PLANNING, ZONING, & BUILDING DEPARTMENT
PZ&B Staff Memorandum: Town Council Development Review

SUBJECT: ZON-22-143 (ARC-22-188) 266 ORANGE GROVE RD (COMBO)

ZON-22-143 (ARC-22-188) 266 ORANGE GROVE RD (COMBO)—VARIANCE. The applicant, Olofson Jeanne H Trust, has filed an application requesting Town Council review and approval for an after-the-fact variance to maintain landscape open space less than the minimum requirements in the R-B zoning district. The Architectural Commission will perform the design review of the application.

Original Approval B-102-2017

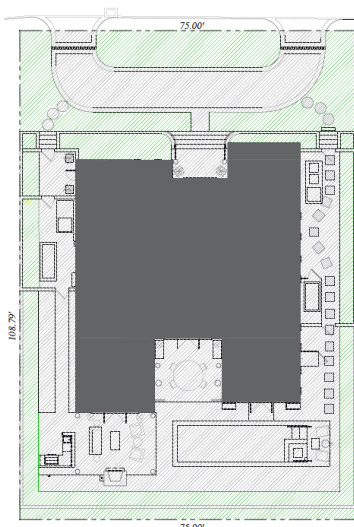
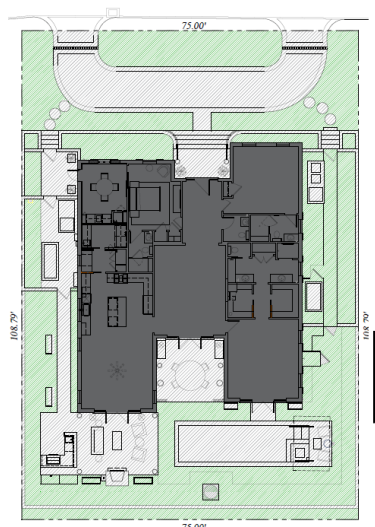
There are considerable improvements proposed with the site work, including an increased native planting schedule and increase over the minimum amount of perimeter and front yard open space (green space)—arguably the most important as it relates to the potential impact of neighboring abutting properties and visual impact from the right-of-way. But the fact remains that the within the timeline of approvals, the overall open space was either disingenuously represented or somehow otherwise erroneously accounted for.

Staff maintains that the applicant should continue to explore ways for further reducing the hardscape in an effort to maximize the amount of overall landscape open space.
